No. 237
Date: 07.09.2011

NEW CHAMBER DESIGN FOR MT5+

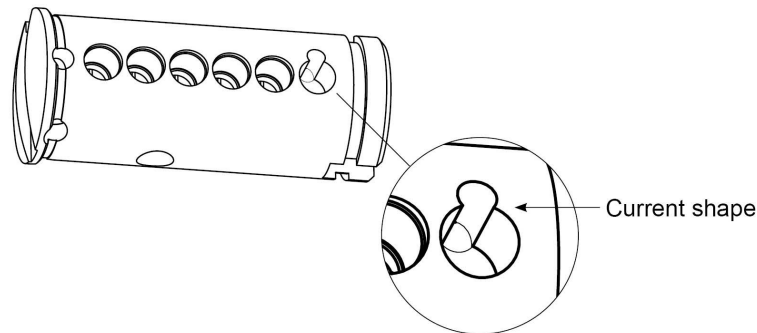
In the near future you may notice that the shape of the eccentric chamber in the plug has been modified.

This new design improves the guide of the eccentric pin inside the chamber after key insertion.

No change has been made to the eccentric pin itself.

The production of the new plugs will start after consuming plugs that are in stock.
